EOCS-BALTIMORE VAMC - LARGE (HOLE) OPENING REPORT

30432 Baltimore VAMC OTF / Baltimore VAMC / 00.0 Basement

EOCS-LOCH RAVEN - LARGE (JOINTS) OPENING REPORT

30432 Baltimore VAMC OTF / Baltimore VAMC / 2.0 2nd Floor

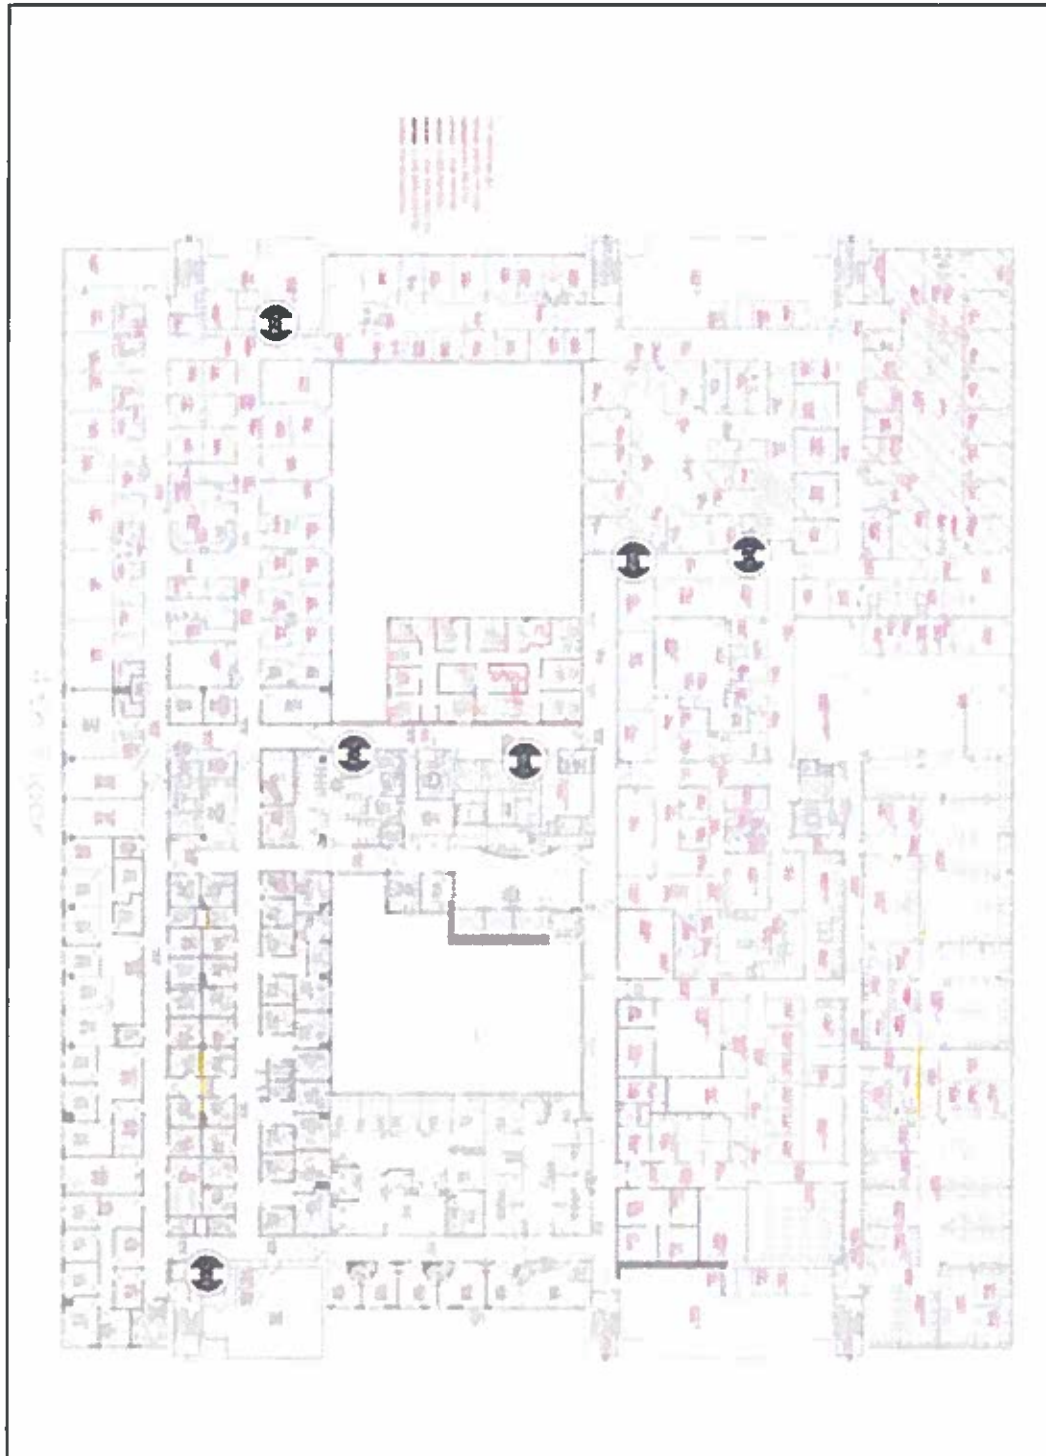
Date Created	Created By	EOCS ID #	Full Plan View	Room Number	Item	Type	Wall Material	Fire Rating	Comments	Width (ft.)	Height (ft.)	Sides	Status
8/20/17	JF	455953	30432 Baltimore VAMC OTF / Baltimore VAMC / 2.0 2nd Floor	2B-118C	Large Opening	Sections of walls missing	Concrete	1 Hour Fire Smoke Barrier	Section of wall missing. 8"x14'	14	1	1	Open

8/20/17 02:58 PM		8/20/17 02:58 PM									
9/4/17	DP	463004	30432 Baltimore VAMC OTF / Baltimore VAMC / 2.0 2nd Floor	2B-111	Large Opening	Sections of walls missing	Gypsum	1 Hour	large opening roughly 6"x48"	4	1	1	Open

9/4/17 01:36 PM											
9/12/17	KA	467524	30432 Baltimore VAMC OTF / Baltimore VAMC / 2.0 2nd Floor	Kitchen	Large Opening	Sections of walls missing	Gypsum	1 Hour Fire Smoke Barrier	Section of wall missing 12" high and 13" wide	1	1	1	Open

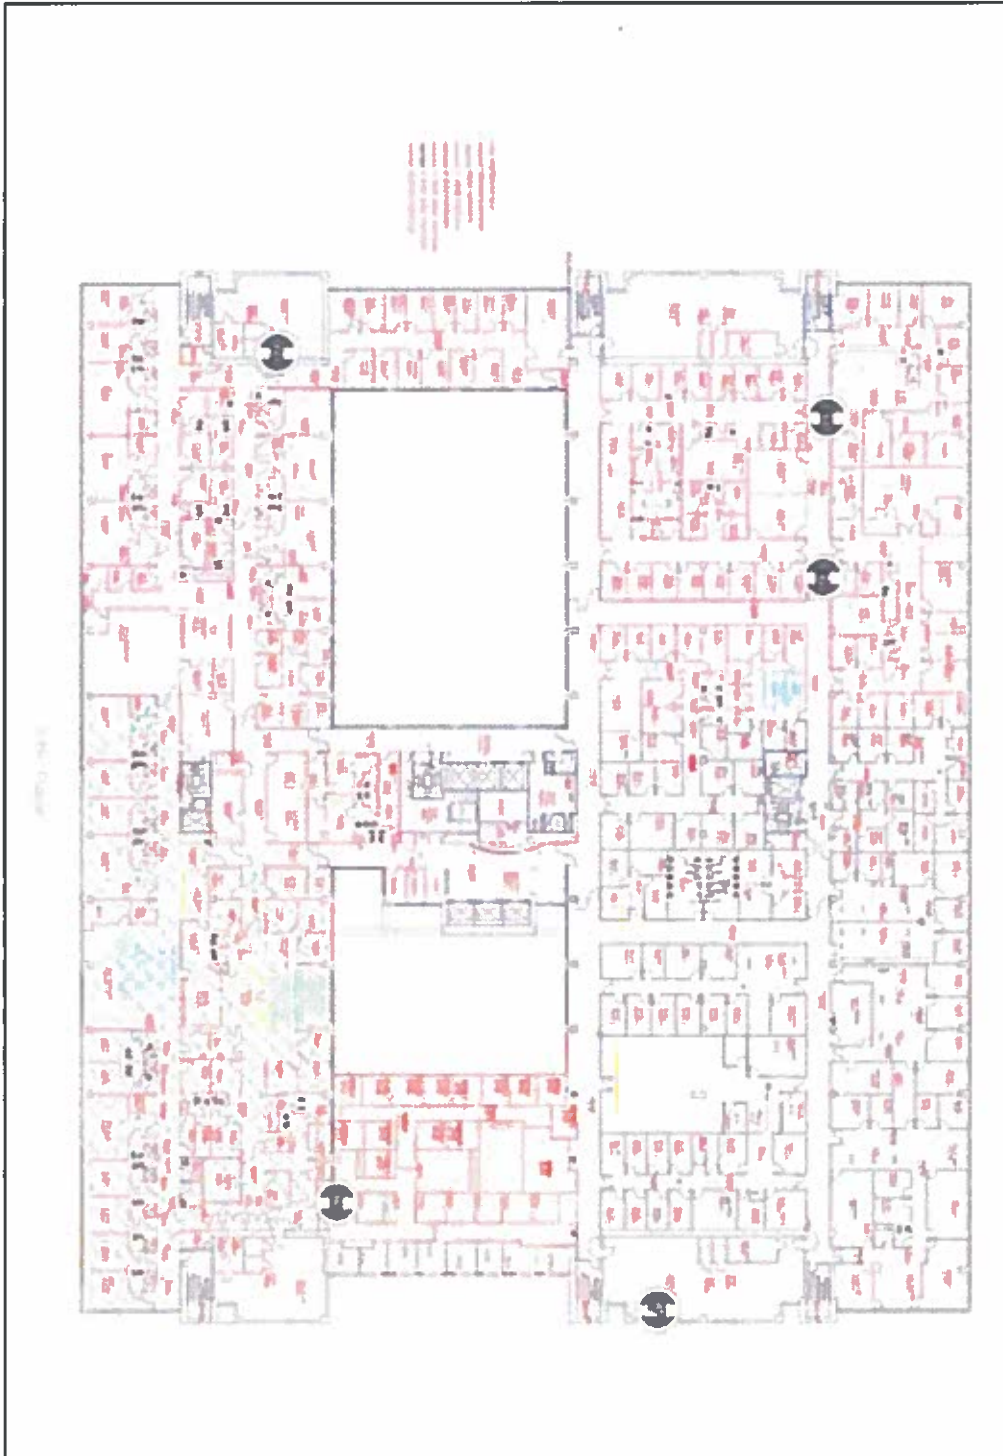
Date Created	Created By	EOCS ID #	Full Plan View	Room Number	Item	Type	Wall Material	Fire Rating	Comments	Width (ft.)	Height (ft.)	Sides	Status
8/20/17	DP	455799	30432 Baltimore VAMC OTF / Baltimore VAMC / 4.0 4th Floor	4B-182	Large Opening	Sections of walls missing	Gypsum	1 Hour Fire Smoke Barrier	12"x14" large opening	1	1	1	Open
 8/20/17 09:25 AM													
8/20/17	DP	455836	30432 Baltimore VAMC OTF / Baltimore VAMC / 4.0 4th Floor	4A-133C	Large Opening	Sections of walls missing	Concrete	1 Hour Fire Smoke Barrier	12"x12"	1	1	1	Open
 8/20/17 10:57 AM													
8/21/17	DP	456977	30432 Baltimore VAMC OTF / Baltimore VAMC / 4.0 4th Floor	Elevator	Large Opening	Sections of walls missing	Gypsum	1 Hour Fire Smoke Barrier	8X18 large opening	2	1	1	Open
8/21/17	JF	456735	30432 Baltimore VAMC OTF / Baltimore VAMC / 4.0 4th Floor	Double Doors	Large Opening	z-other	Gypsum	1 Hour Fire Smoke Barrier	Scab Patch. 14"x16"	1	2	1	Open

8/21/17 10:39 AM													
8/21/17	DP	456986	30432 Baltimore VAMC OTF / Baltimore VAMC / 4.0 4th Floor	Double doors	Large Opening	z-other	Gypsum	2 Hour Fire Smoke Barrier	12X12	1	1	1	Open

8/21/17 11:01 AM										
9/1/17	JF	462288	30432 Baltimore VAMC OTF / Baltimore VAMC / 4.0 4th Floor	4A-102	Large Opening	Through Penetrations	Gypsum	1 Hour Fire Smoke Barrier	Section of wall missing 8"x20" with metallic pipe penetration	2	1	1	Open

LOCH RAVEN CLC 2ND FLOOR

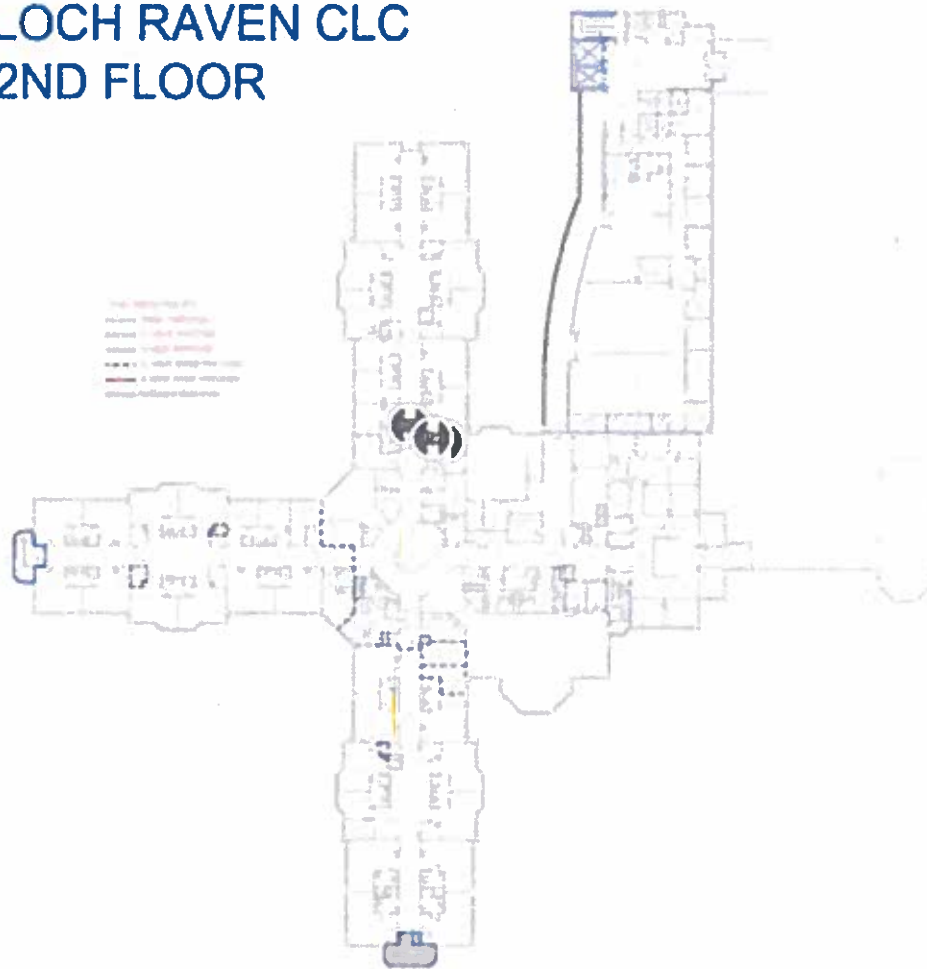
Date Created	Created By	EOCS ID #	Full Plan View	Room Number	Item	Type	Wall Material	Fire Rating	Comments	Width (in.)	Length (ft.)
9/15/17	JF	469772	30432 Baltimore VAMC OTF / Loch Raven -Offsite / 2.0 2nd Floor	Double Doors	Large Opening	Joints	Gypsum	1 Hour Fire Smoke Barrier	Foreign material needs to be removed. HOW needs to be stuffed and sealed 1.5"x10'x2	1.5	20

9/15/17 02:26 PM	9/15/17 02:27 PM	9/15/17 02:27 PM						
9/15/17	SO	469733	30432 Baltimore VAMC OTF / Loch Raven -Offsite / 2.0 2nd Floor	2B-14	Large Opening	Joints	Gypsum	1 Hour Fire Smoke Barrier	HOW needs sealed to ceiling. 1in. by 25ft.	1	25

9/15/17 02:32 PM	9/15/17 02:32 PM							
9/15/17	SO	469742	30432 Baltimore VAMC OTF / Loch Raven -Offsite / 2.0 2nd Floor	Room 2B-16	Large Opening	Joints	Gypsum	1 Hour Fire Smoke Barrier	HOW needs stuffed and sealed to fluted ceiling. 4in. by 24ft.	4	24
